POWER-UNIT No. 69A
50V NOMINAL DC SUPPLY FROM 50Hz A.C. MAINS
(45V AT 4.0A)

N672
ISSUE C

N672
ISSUED

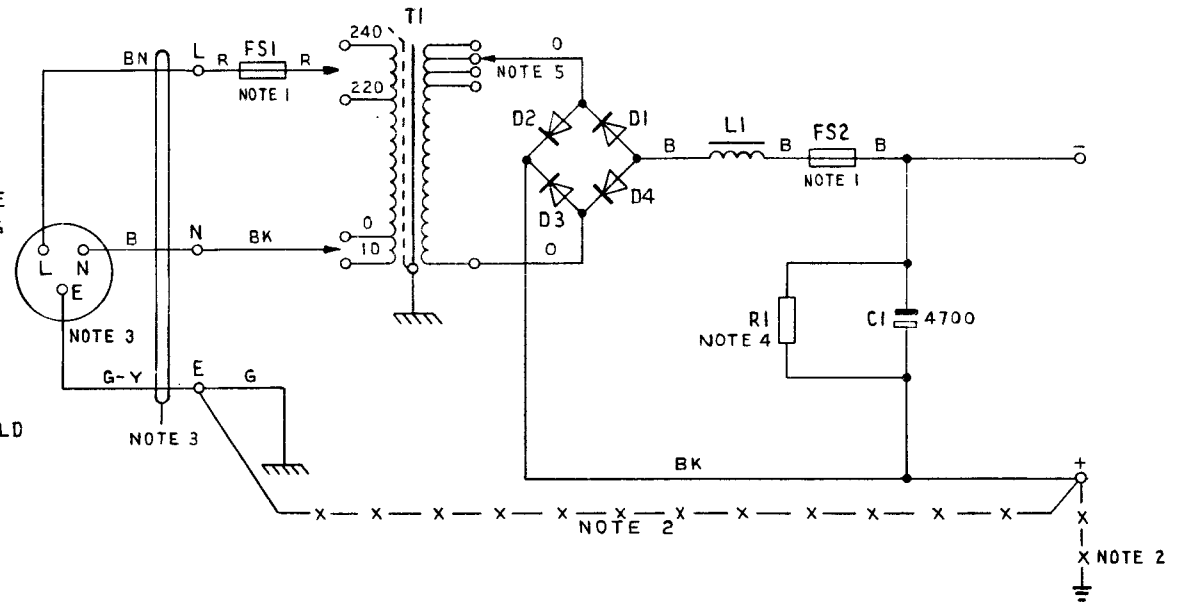
P.O TELECOMMS HQRS PAPER:- W DISTN :- GENERAL	ISSUE			
		C	NEW FORMAT. TRANSFORMER 200V. TAPPING REMOVED. WIRE COLOURS & CAPACITOR VALUE CHANGED. NOTES 2 & 3 AMENDED. NOTE 5 ADDED. DLW TD 7.2.3	31.1.77
		B	NEW FORMAT KMA	8-7-66

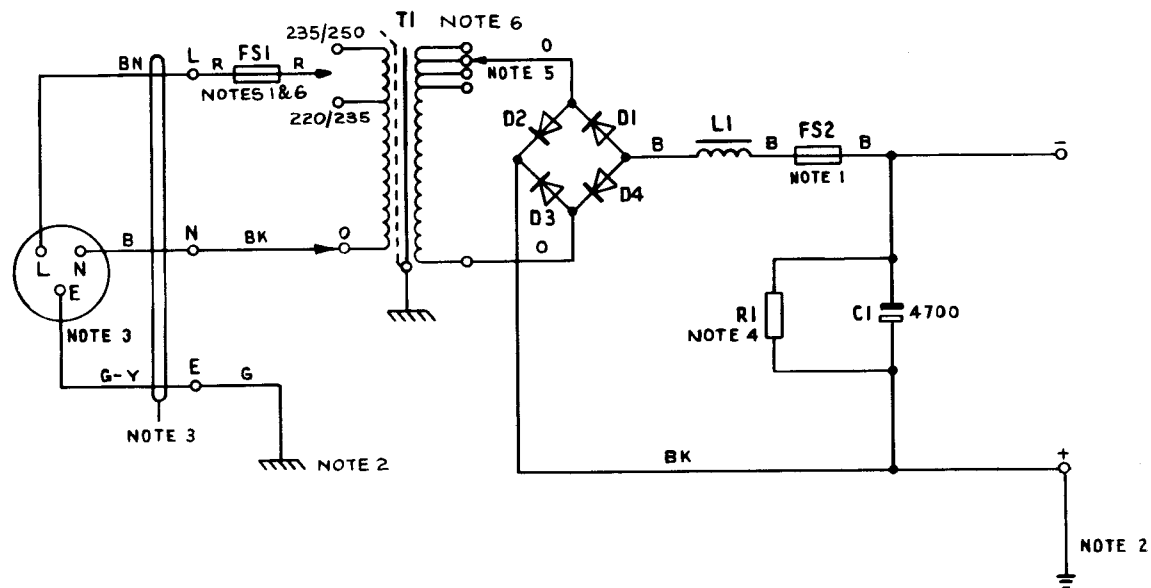
BRITISH TELECOMMS HQRS PAPER:- W DISTN :- GENERAL	ISSUE	D	NOTE 6 ADDED. NOTES 1, 2 & 3 AMENDED. MINOR AMENDMENTS. <i>to diff</i> RAG SE 2.1.2	19-12-83
		C	NEW FORMAT. TRANSFORMER 200V. TAPPING REMOVED. WIRE COLOURS & CAPACITOR VALUE CHANGED. NOTES 2 & 3 AMENDED. NOTE 5 ADDED. DLW TD 7.2.3	31-1-77
			NEW FORMAT KMA	8-7-66

1. FS1 :- FUSE No. 80A/2.0 FS2 :- FUSE No. 36A/5
2. ONE SIDE OF THE OUTPUT (NORMALLY +) SHOULD BE CONNECTED, WITH WIRE, EARTHING 9141 OR 9142, TO THE TELEPHONE SIGNALLING EARTH, WHICH MUST BE PROVIDED USING ONE OF THE METHODS SHOWN IN TI A2 E1006. SEE ALSO SPECIFICATION D1921. THE MAINS PROTECTIVE EARTH MUST NOT BE UTILISED FOR THE TELEPHONE SIGNALLING EARTH. THE MAINS PROTECTIVE EARTH SHALL BE CONNECTED TO THE EARTH CONNECTING BLOCK OF THE POWER-UNIT WITH 1.5 mm² CONDUCTOR.
3. CORD, FLEXIBLE 3183 Y 1.5 mm², AND PLUG No. 103 TO BE REQUISITIONED SEPARATELY AND FITTED LOCALLY. PLUGS SHALL BE FITTED WITH 3 AMP FUSES.
4. VALUE CHOSEN BY MANUFACTURER.
5. THESE TAPS ARE SET BY THE MANUFACTURER AND SHOULD NOT NORMALLY NEED TO BE DISTURBED.
6. EARLIER VERSIONS OF THE POWER-UNIT MANUFACTURED BEFORE 1983 SHOW DIFFERENT PRIMARY TAPPINGS ON T1. FUSE No. 80A/... (FS1) WAS FUSE No. 36A/...
